Bentley Bulletin

22-032

April 1, 2022

Subject: RECALL CAMPAIGN – Bentley Continental GT, Continental GT Convertible and Flying Spur Incorrect Seat Belt Fitted Recall (RE22/08)

Figure 2

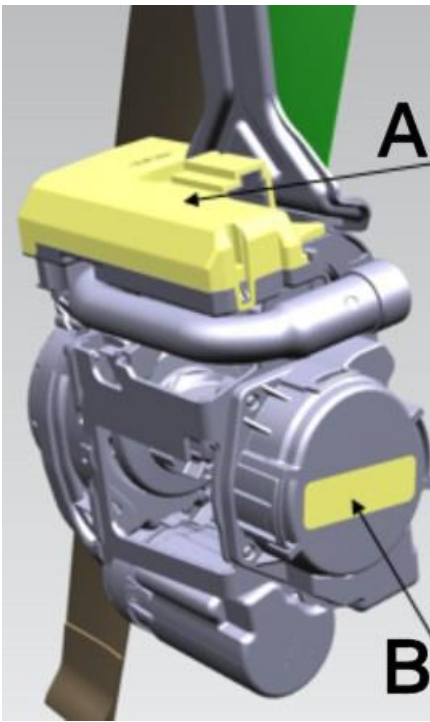
Figure 2 shows the location in which the label is fitted (Depending on Model Year)

- Point A - 22 M/Y onwards
- Point B - Up to 22 M/Y

HINT: In the event that a front seatbelt has previously been replaced on a vehicle prior to 22 M/Y please be aware that the required identification label may not be at Point B as the part supplied could be a later/superseded part

Seat belt assemblies with the Identification label as Figure 2 (A)

The operative should use a Borescope (see Tools section) if required to obtain a clear photograph of the identification label Note: New Continental GTC models will require the water deflectors removing to gain access to the identification label

Seat belt assemblies with the Identification label as Figure 2 (B)

As the label is on the side of the seatbelt, Referring to Rep.Gr 69 - The operative must remove the front seat assemblies to obtain a clear photograph of the identification label Note: Ensure the lower seatbelt fixing and washer is always replaced as per Rep.Gr 69 instructions

Figure 13

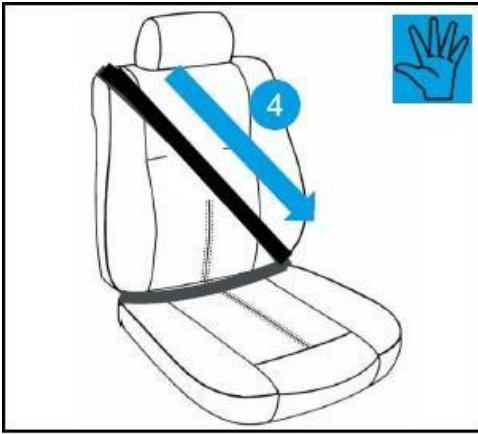
15) Grasp the torso portion of the seatbelt and carefully, (Ensuring the inertia lock is not initiated), pull the seatbelt back out of the retractor. The belt should pull out of the retractor as there is no ALR function on the driver's seat (Figure 13)

Driver's seat belt evaluation:

Does the driver's seatbelt lock so that the strap cannot be pulled out of the retractor (step 15) five times in succession?

Yes: The seatbelt MUST be replaced Refer to Rep.Gr 69 IMPORTANT: please ensure a photograph of the replacement seat belt identification is taken and saved as this will be required later in the process - Referring back to Figure 1 locate the identification label (Depending on model year see Figure 2 for label location)

No: The seatbelt function works properly and the driver seatbelt assembly meets requirements go to step 18 - Identification label recording of the left and right hand seat belt
